PIC16F/LF1933 Silicon Errata and Data Sheet Clarification

The PIC16F/LF1933 devices that you have received conform functionally to the current Device Data Sheet (DS41364D), except for the anomalies described in this document.

The following typographic corrections and clarifications are to be noted for the latest version of the device data sheet (DS41364D):

FIGURE 1: INSTRUCTION CYCLE DELAY CALCULATION EXAMPLE

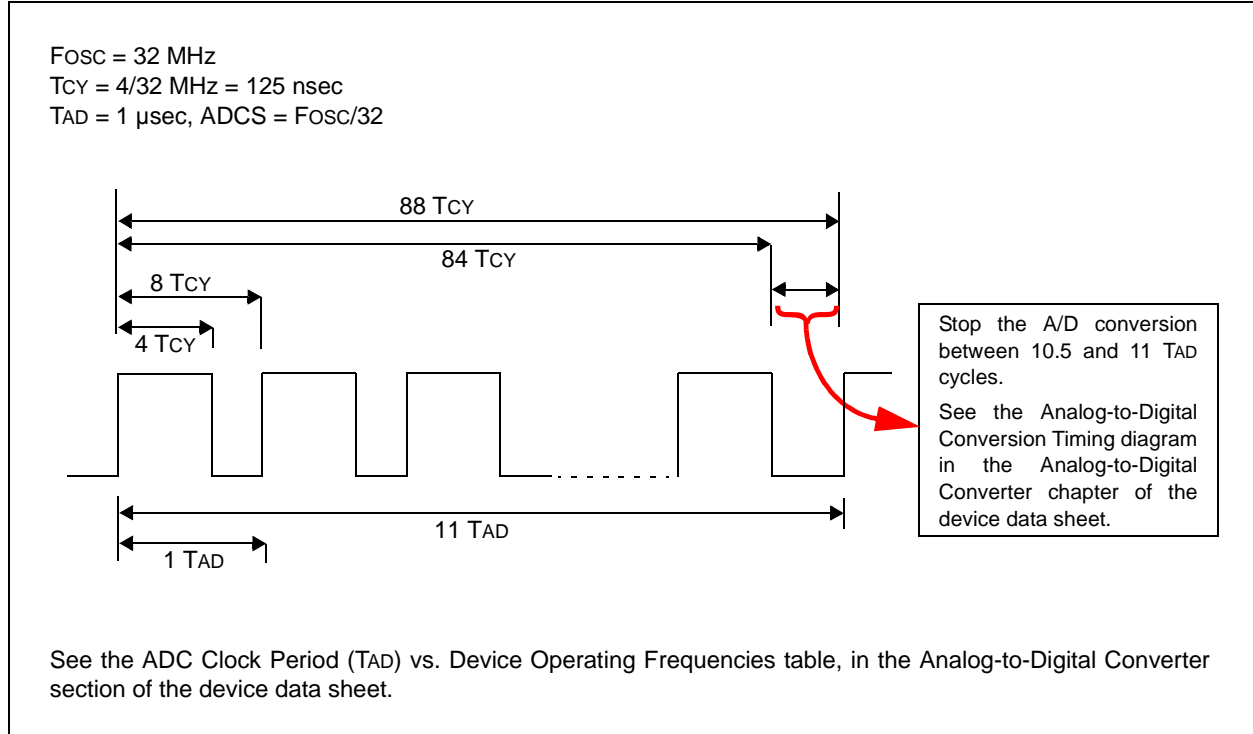
An ADC conversion may not complete under these conditions:

1. When FOSC is greater than 8 MHz and it is the clock source used for the ADC converter.
2. The ADC is operating from its dedicated internal FRC oscillator and the device is not in Sleep mode (any FOSC frequency).

When this occurs, the ADC Interrupt Flag (ADIF) does not get set, the GO/DONE bit does not get cleared, and the conversion result does not get loaded into the ADRESH and ADRESL result registers.

Method 3: This method is provided if the application cannot use Sleep mode and requires continuous operation at frequencies above 8 MHz. This method requires early termination of an ADC conversion. Provide a fixed time delay in software to stop the A-to-D conversion manually, after all 10 bits are converted, but before the conversion would complete automatically. The conversion is stopped by clearing the GO/DONE bit in software. The GO/DONE bit must be cleared during the last ½ TAD cycle, before the conversion would have completed automatically. Refer to [Figure 1](#) for details.

In [Figure 1](#), 88 instruction cycles (TCY) will be required to complete the full conversion. Each TAD cycle consists of 8 TCY periods. A fixed delay is provided to stop the A/D conversion after 86 instruction cycles and terminate the conversion at the correct time as shown in the figure above.

Note: The exact delay time will depend on the TAD divisor (ADCS) selection. The TCY counts shown in the timing diagram above apply to this example only. Refer to [Table 4](#) for the required delay counts for other configurations.

FIGURE 29-3: HFINTOSC FREQUENCY ACCURACY OVER DEVICE V_{DD} AND TEMPERATURE

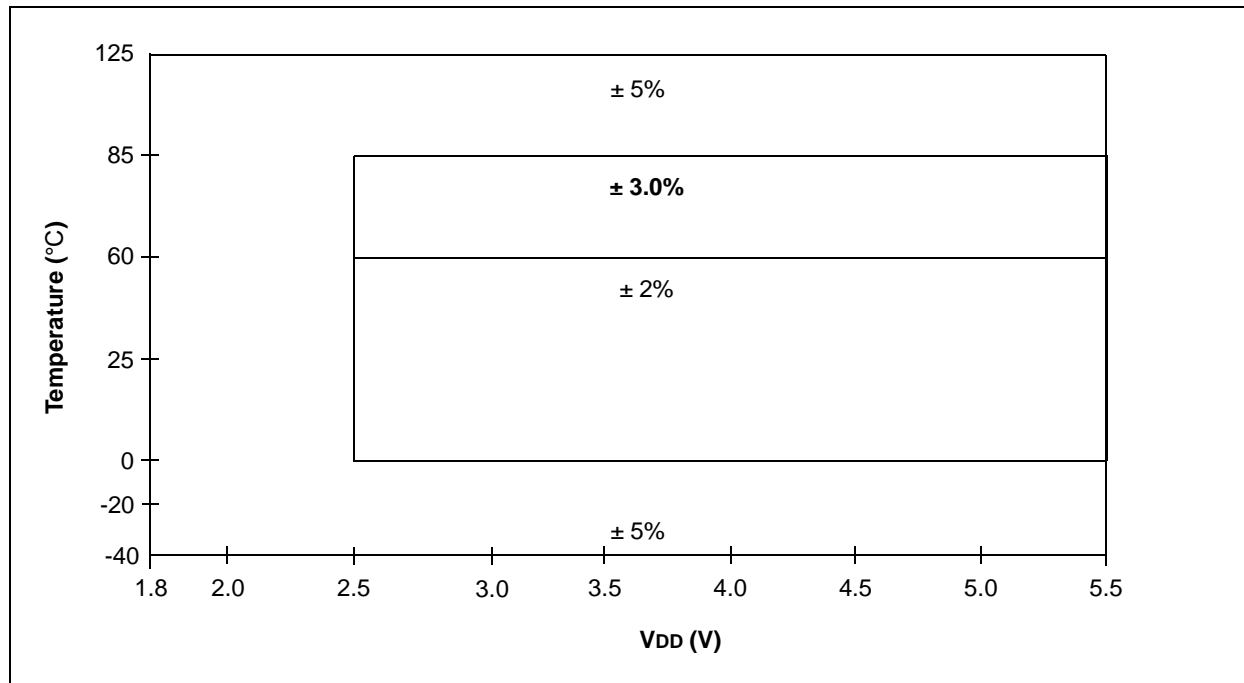
In Figure 29-3, HFINTOSC Frequency Accuracy Over Device V_{DD} and Temperature, the oscillator accuracy should be +/- 3.0% when V_{DD} is equal to, and above 2.5V and when temperatures are equal to, and above 60°C, yet still equal to, or below 85°C, as shown below.
